**Consultation Response from KC,
Lead Local Flood Authority**

2023/92490 Former Dowker Works, Dowker Street, Milnsbridge, Huddersfield, HD3 4JX

Erection of 38 dwellings with associated access and landscaping (within a Conservation Area)

Date Responded: 13th October 2023

dowker street
Scale = 1:952.560
maps@kirklees.gov.uk

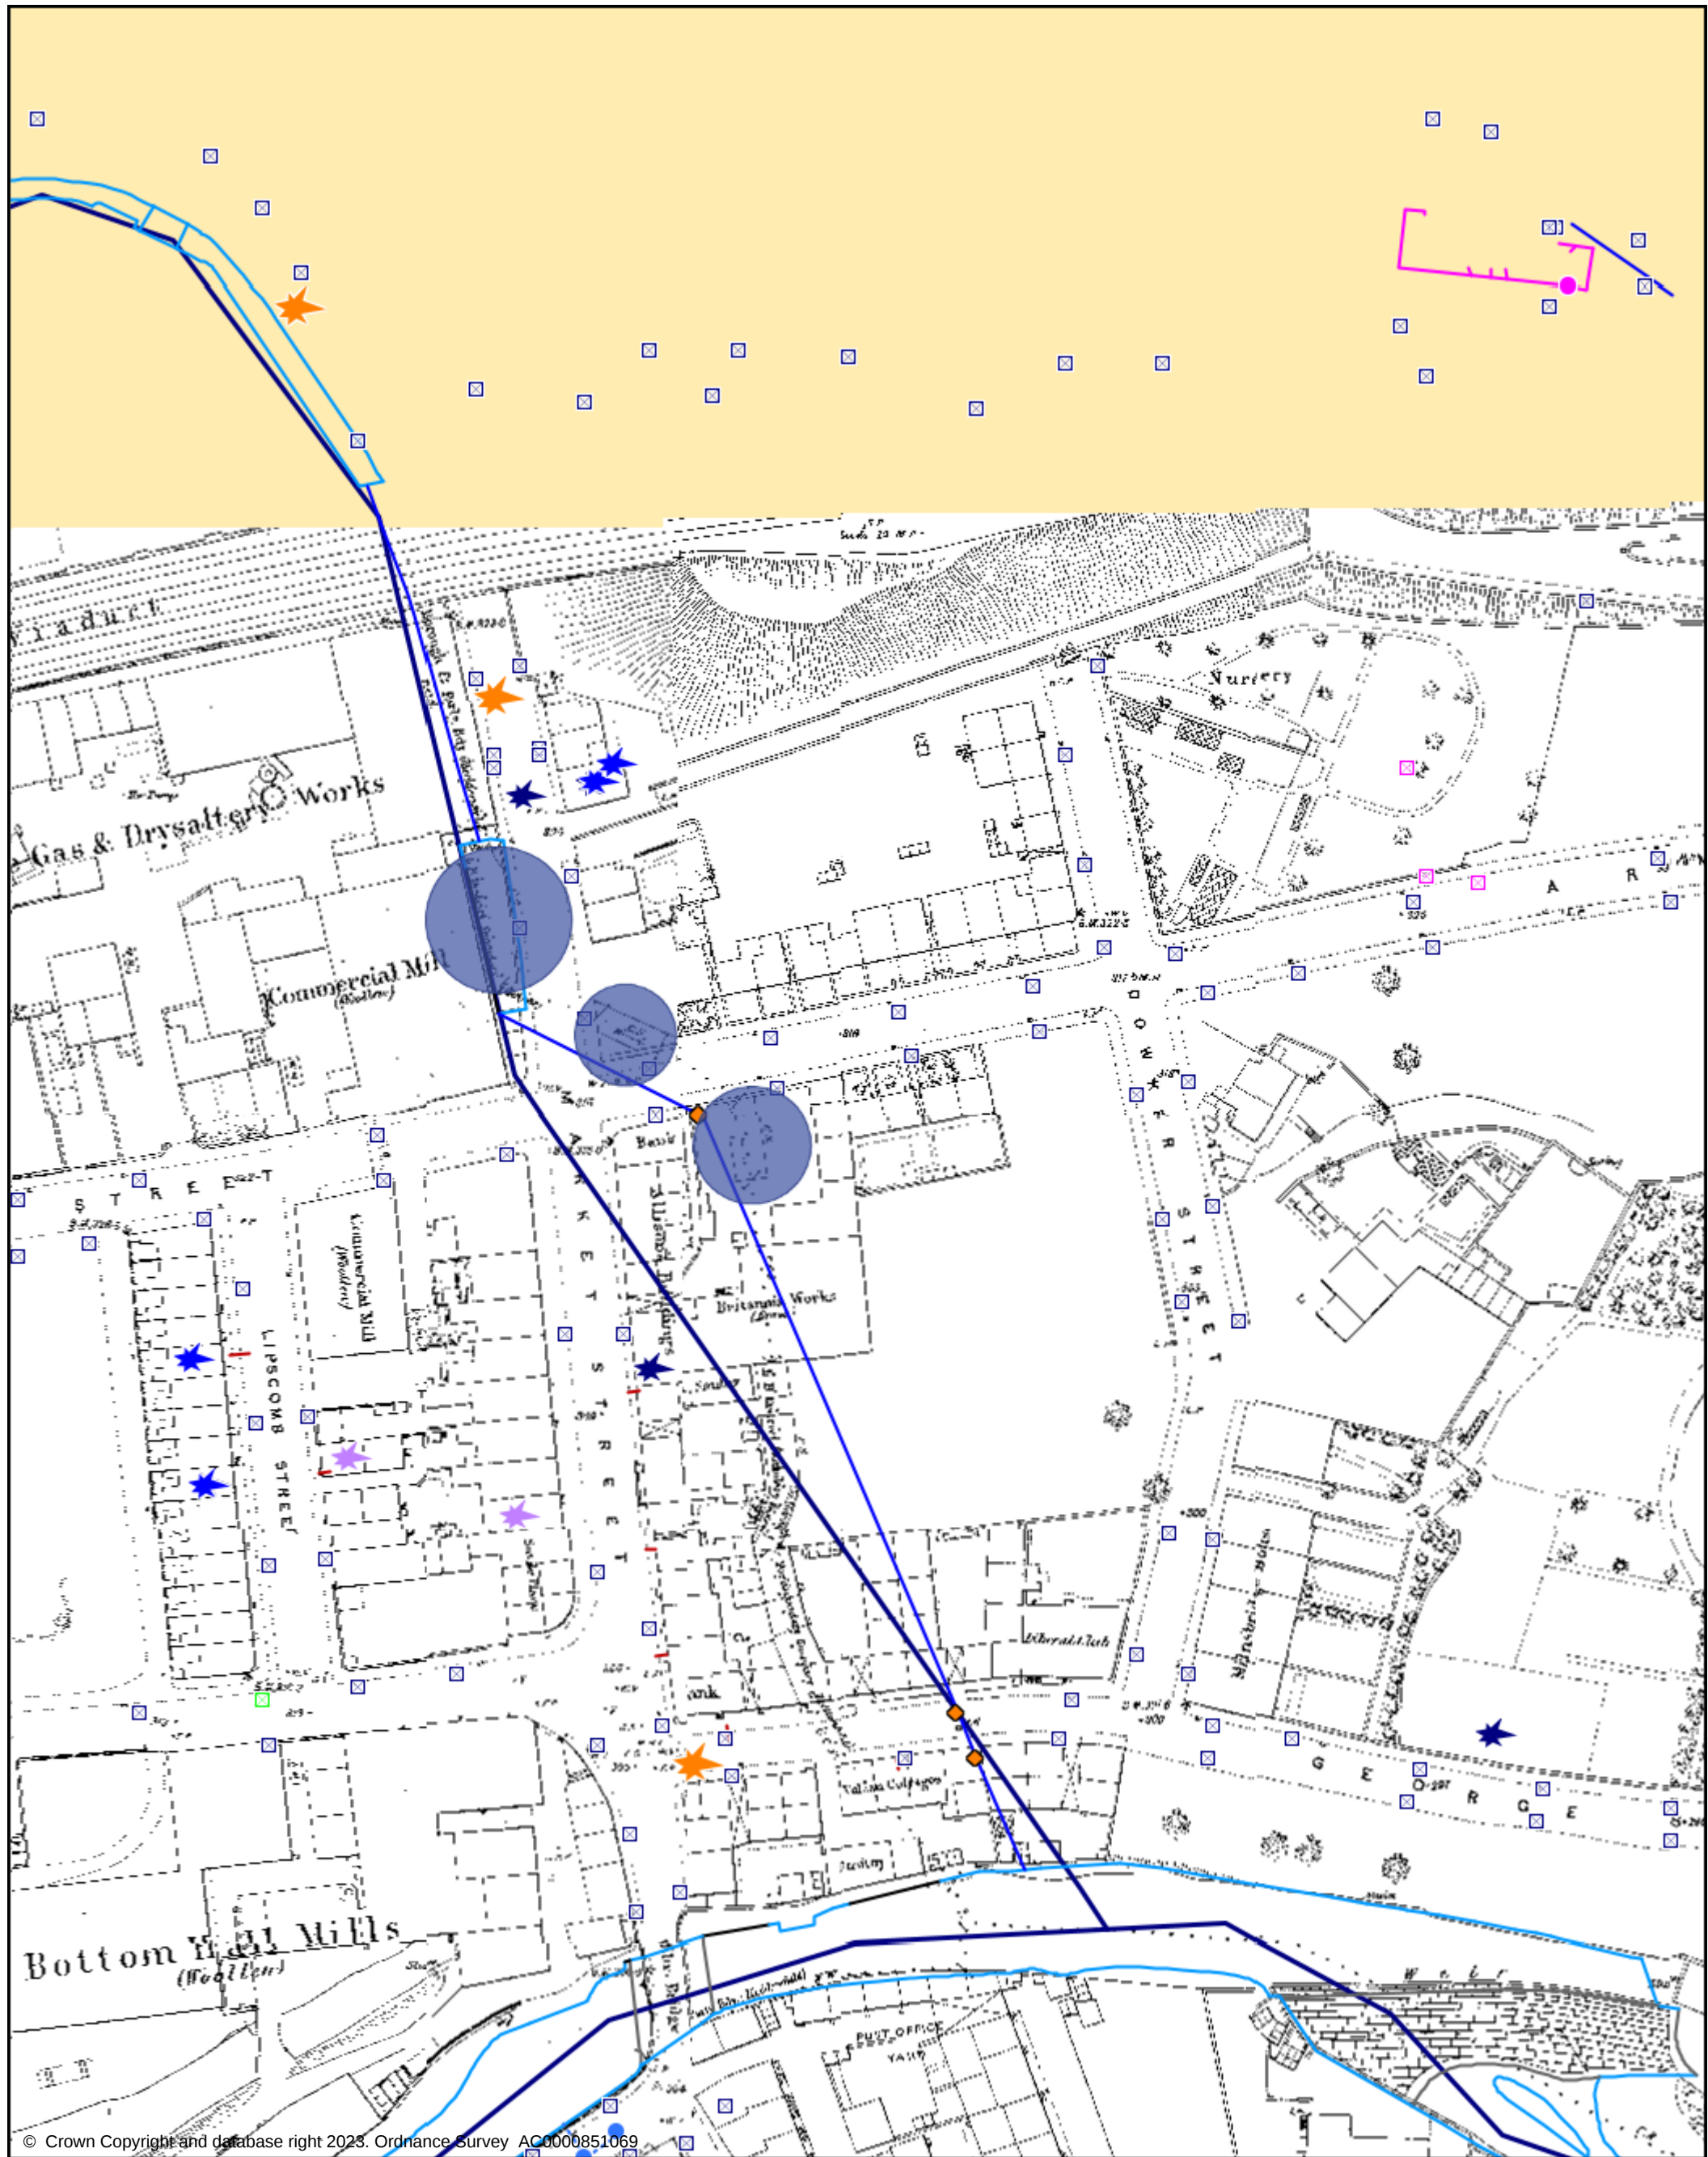
The FRA does recognise the presence of a 300mm public combined sewer within the site that follows old street patterns. An attribute change is shown at the head of the system on the statutory record. This means that this sewer could extend further into the site and needs to be surveyed for remaining live connections. Any closure or diversion of this system must have full agreement from the Statutory Undertaker.
